for the King City LM6000 Project

Submitted to: California Energy Commission Sacramento, California

April, 2001

CALPINE KING CITY – FIRST DRAFT REVIEW COPY EMERGENCY PERMIT COMPLETENESS CHECKLIST CALIFORNIA ENERGY COMMISSION

15.1 Plan for landscaping and screening to meet local requirements

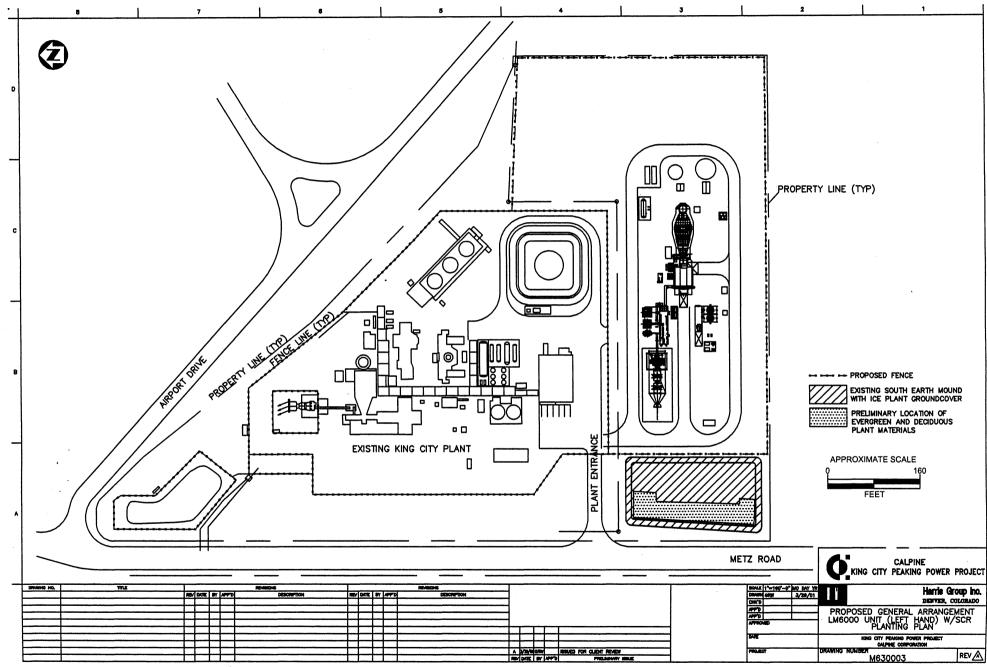
REQUIREMENT	<u>Y/N</u>	Application pages	Comments
15 Visual resources			
15.1 Plan for landscaping and screening to meet local requirements	Yes	15-1	Fencing not shown on plans. Landscape plans are very minimal – for instance, what are plans for grassy area as shown in Fig. 15-4
15.2 Full size color photo of the site and rendering of proposed facility with any proposed visual mitigation if available	Yes	15-4	Rendering not available.
16 Transmission System Engineering			
16.1 Conformance with Title 8, High Voltage Electrical Safety Orders, CPUC General Order 95 (or NESC), CPUC Rule 21, PTO Interconnection Requirements, and National Electric Code	Yes	16-1

The landscape plan for the proposed power plant (shown on Figure 15-2) comprises the existing southern earth mound and groundcover with the addition of evergreens and deciduous plant materials to meet the requirements set forth in 17.30.130, Minimum Landscaping Standards and to blend with the existing planting plan. Also a fence will be installed around the periphery of the LM6000 facility similar to the chain link fence around the King City Cogeneration Facility. Additional requirements will be discussed with the Planning Director and as appropriate the architectural review committee. Based on these discussions, a final landscape plan will be prepared and plant materials will be installed as part of development of the LM6000 project.
